Ref: 230-004-004L

**6 Endeavour Road, Port Douglas
Operational Works Application OP 2023_5480/1
Response to Information Request**

We refer to Council's information request for the above application dated 17 August 2023 (copy attached) and respond as detailed below.

ENDEAVOUR STREET SUBDIVISION	
EROSION & SEDIMENT CONTROL STRATEGY	
DRAWING NO.	230-004-C13
REVISION	B

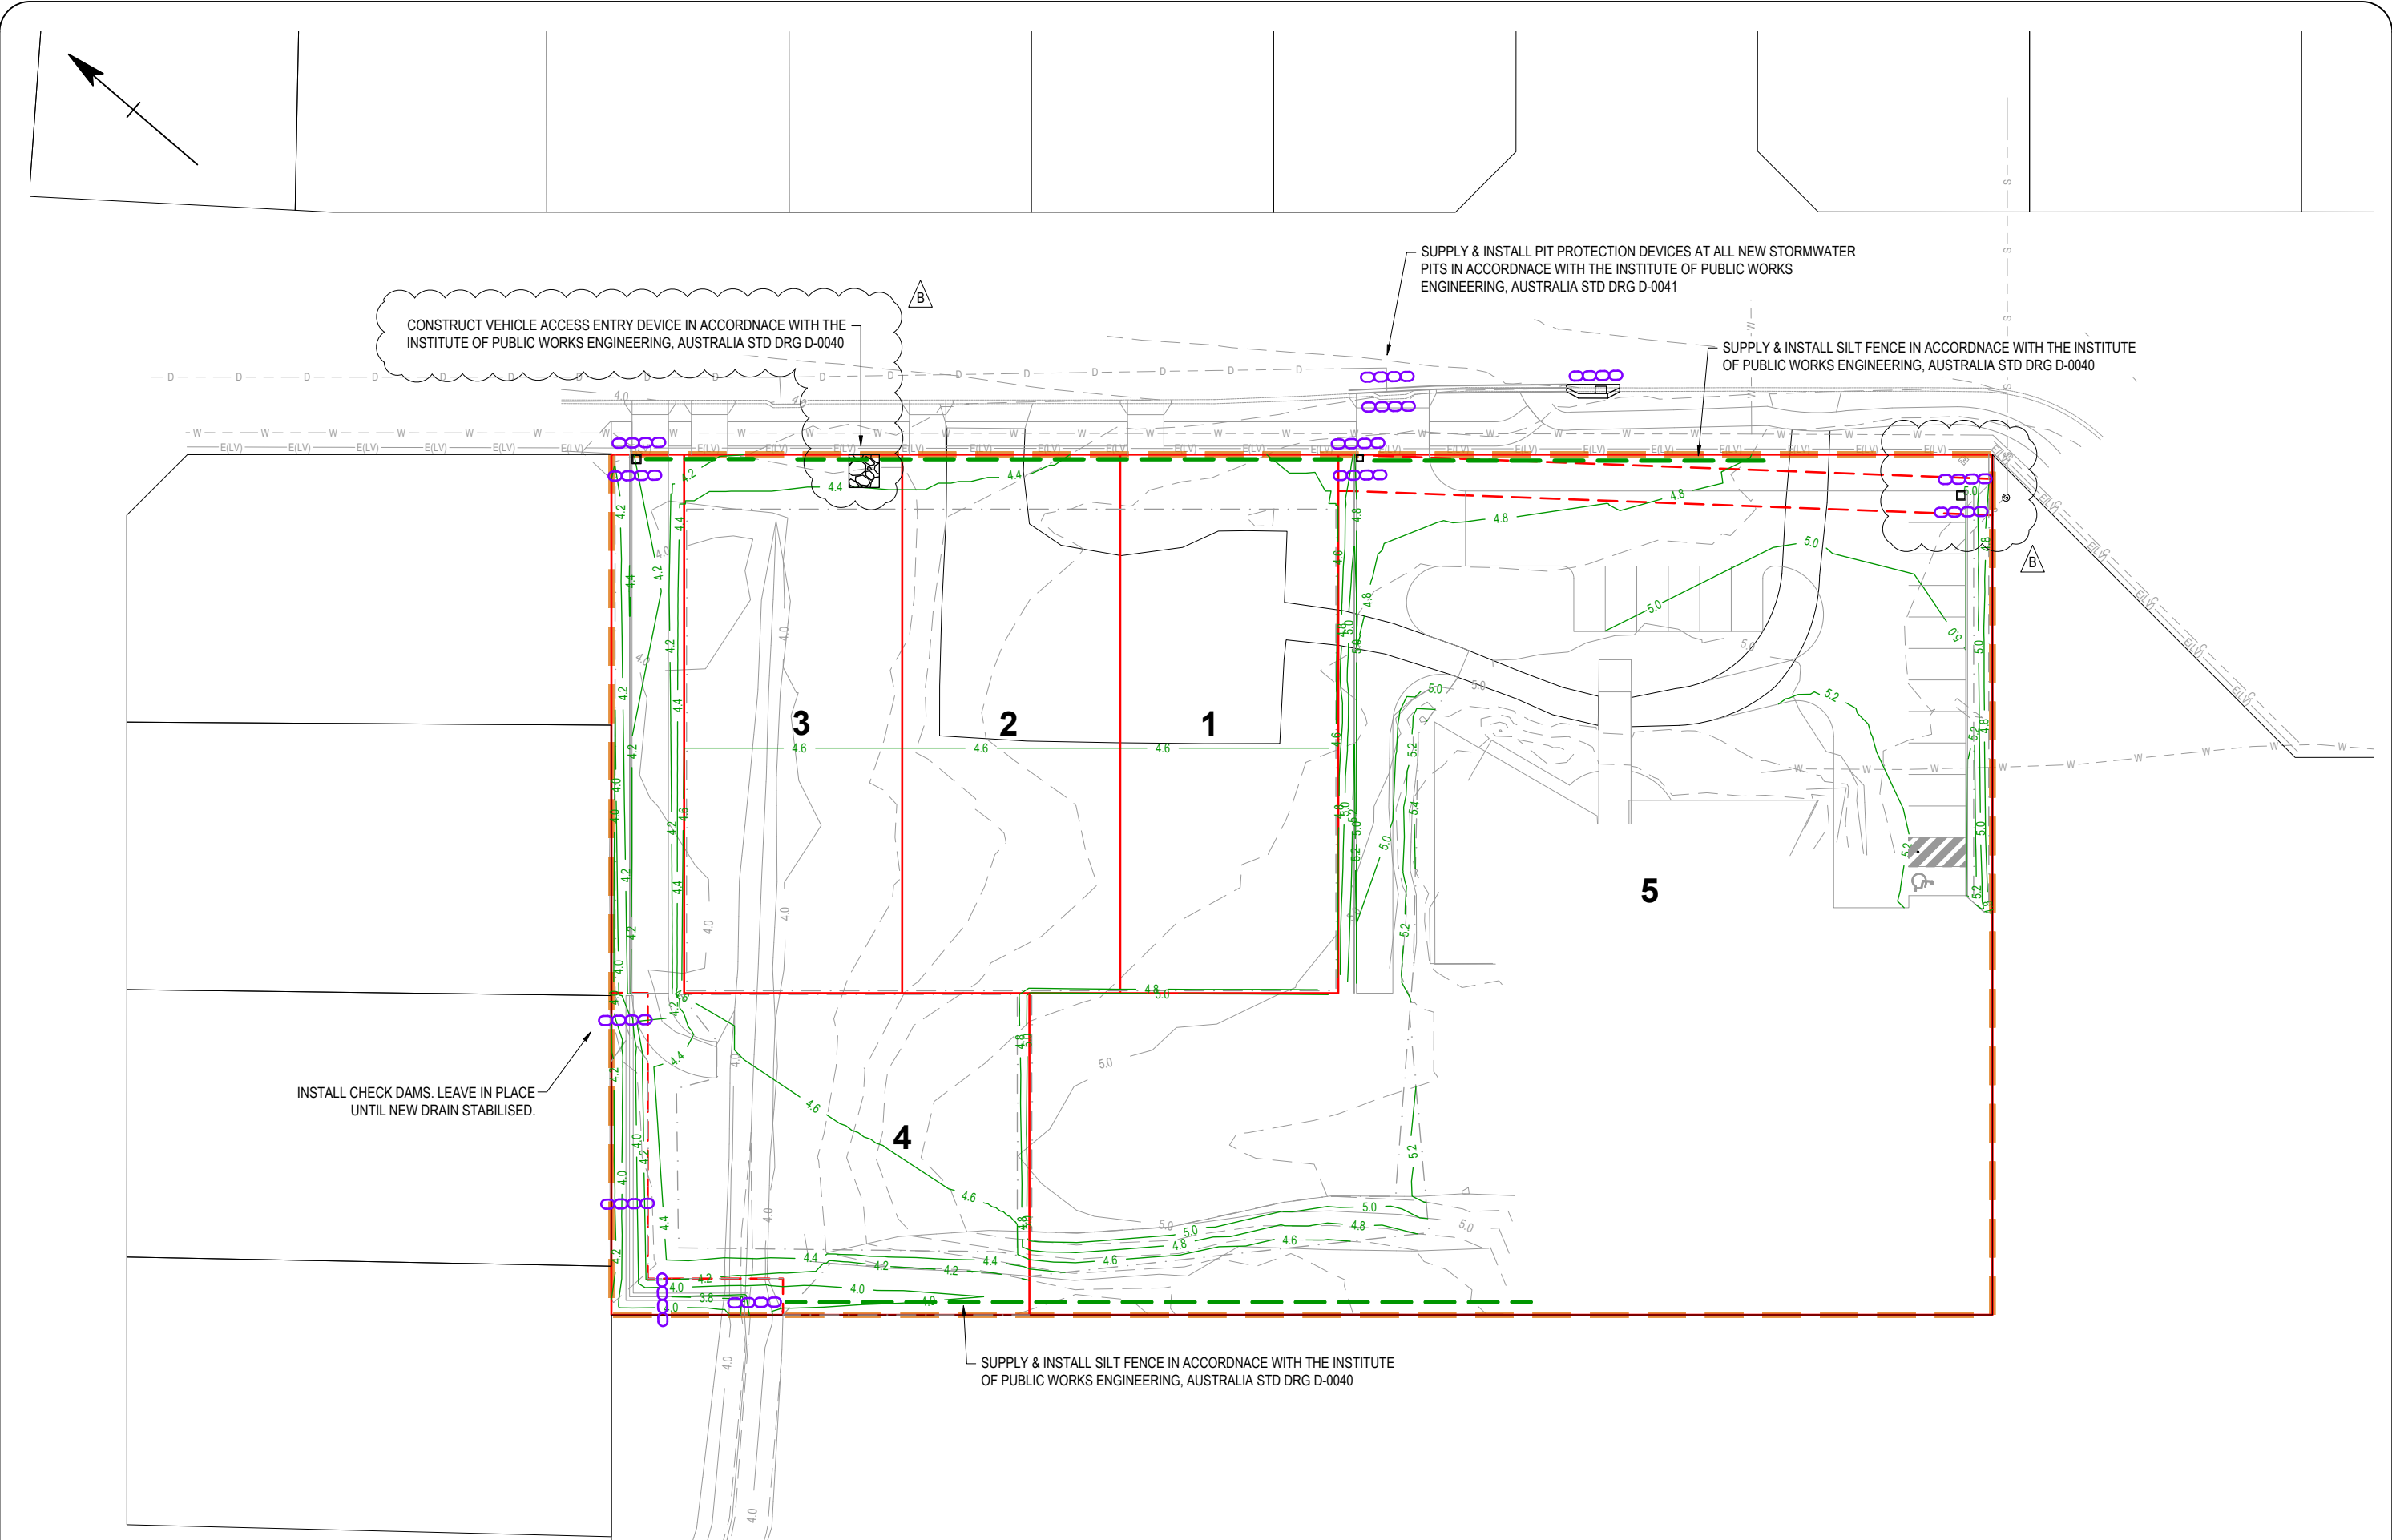
Item 9 – Site Construction Access

The proposed site access location has been amended to be positioned clear of the existing kerb inlet pit.
